## REGIONAL FARE COORDINATION SYSTEM

### CHANGE ORDER NO. 32

**CONTRACTOR:** ERG Transit Systems (USA) Inc.  
**CONTRACT NUMBER:** 229944

**Figure III-4.1 (KCM)**

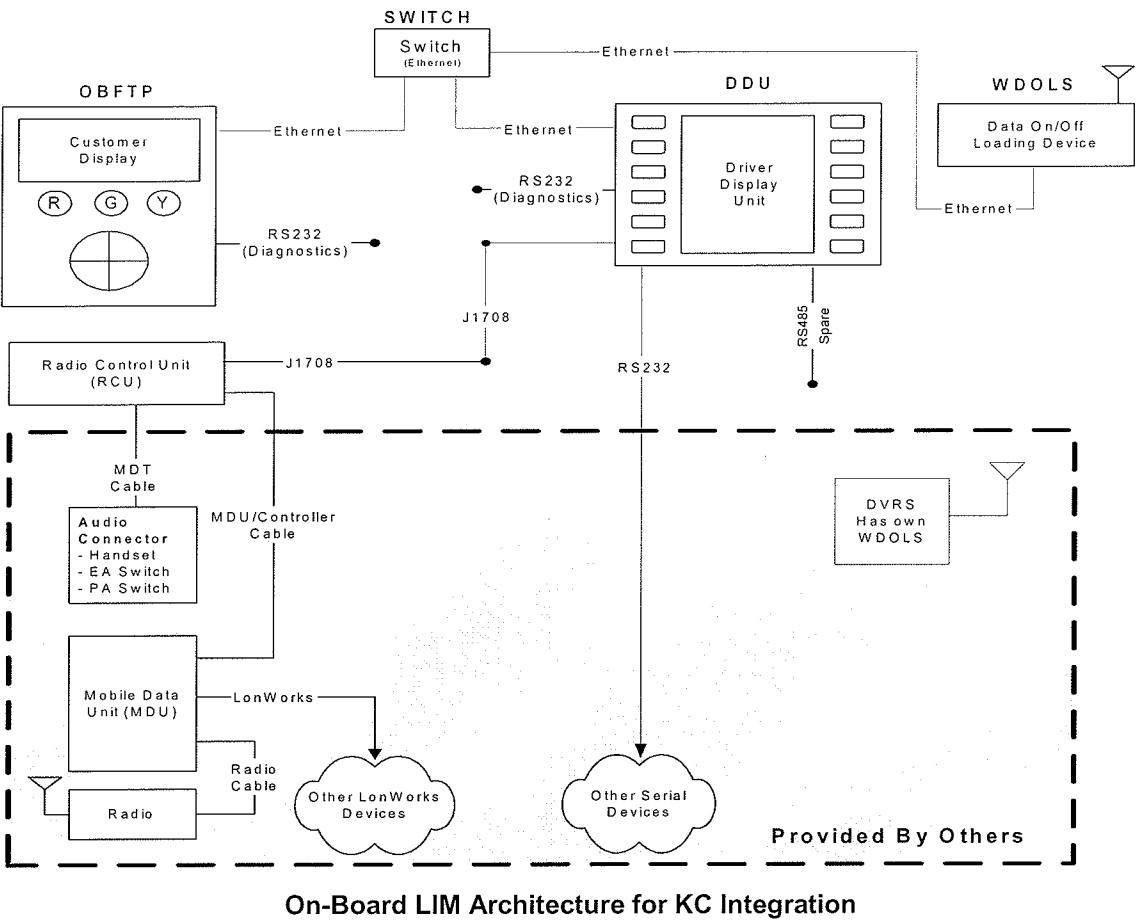
In the Limited Integration Mode, the OBFTP shall store transactions until communication with the WDOLS is established and data transfer can be completed. The OBFTP shall connect to other on-board devices as illustrated in Figures III-4.1 and III-4.2.

**Figure III – 4.3 (KCM - revised by C.O. 32)**

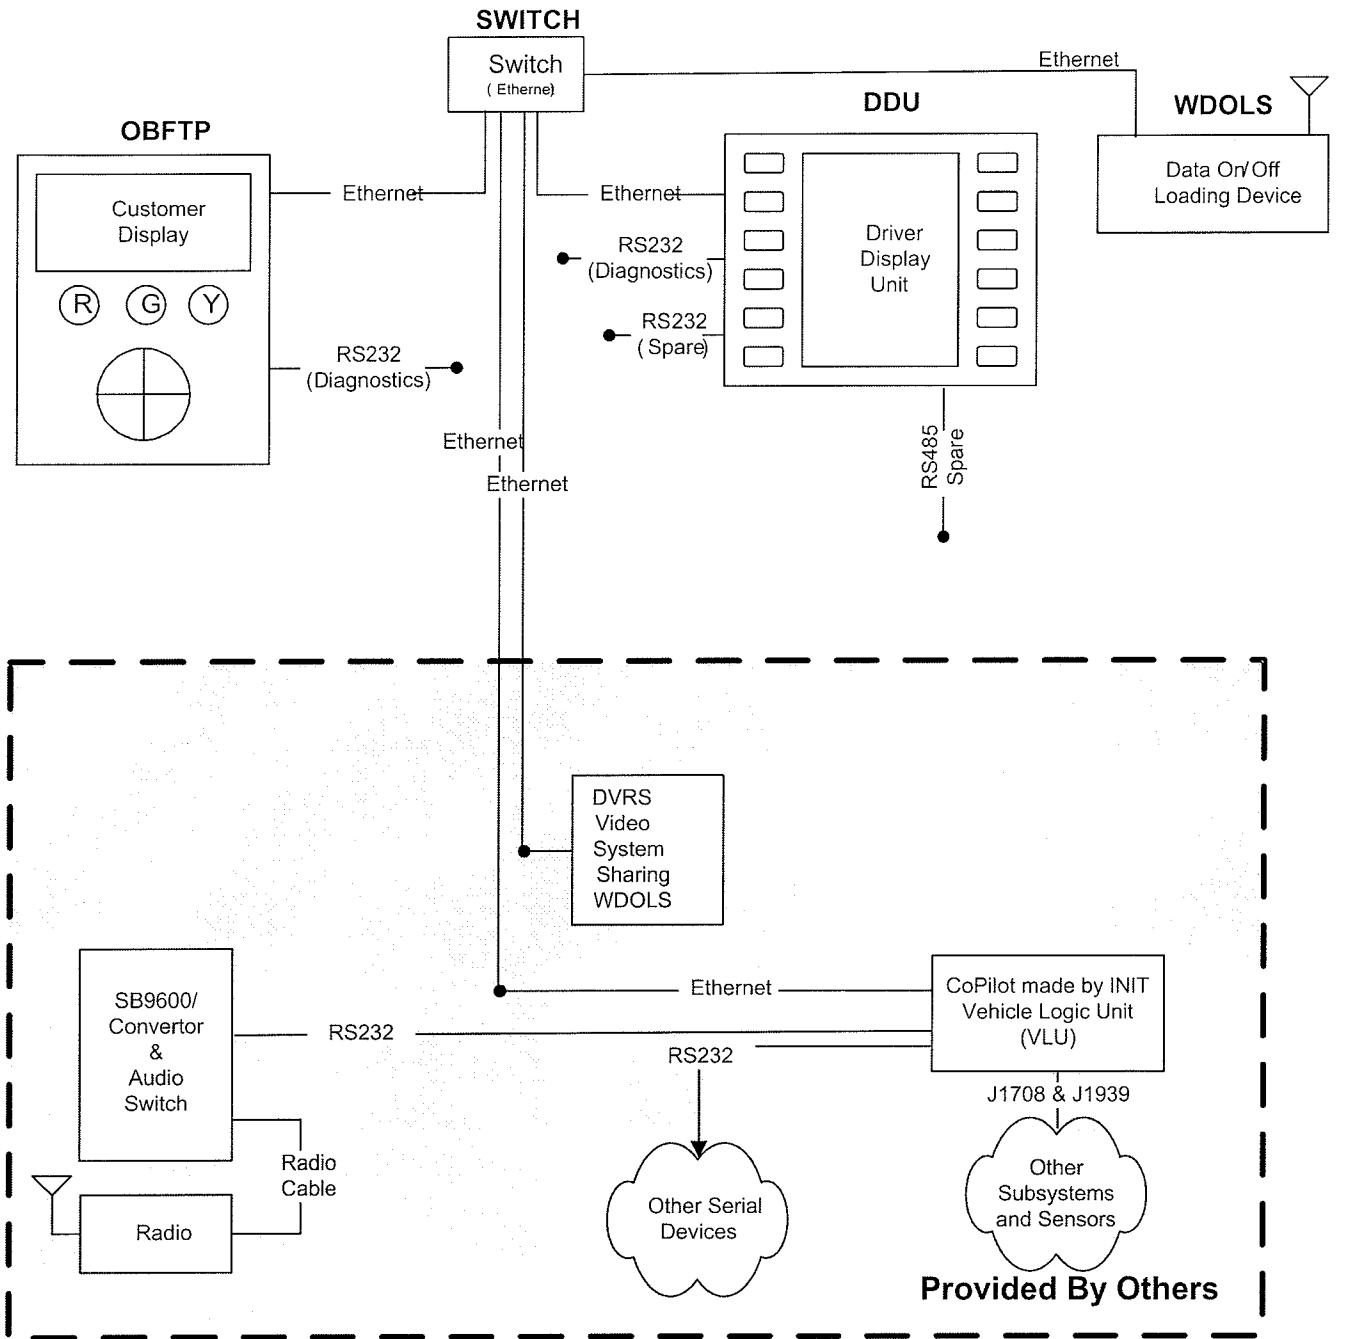
In the Full Integration Mode, the VLU, DDU and the OBFTP shall share the use of the WDOLS for coaches owned or operated by King County. When communication is established via the WDOLS, then the data transfers for each device will be handled in parallel until all are completed. The OBFTP, DDU and WDOLS shall be connected as illustrated in Figures III-4.3 and III-4.4.

The Ethernet switch shall act as the interface between the OBFTP, DDU and VLU. The VLU shall send data and information as described herein to the DDU. The DDU will share the information from the VLU with the (AFC Application) by use of the DDU Common Store. An Ethernet/High Speed Serial interface shall be used for on/off-loading data via the WDOLS. Data provided by the VLU will include the variables described in Section 6.III-6.8.4, including but not limited to: login data (route/run/trip), trip change prompts, fareset changes and, if the ERG option is exercised, Stop ID data. The AFC Application will update the Common Store variables needed by the OBS, including but not limited to: operator login and default trip fareset.
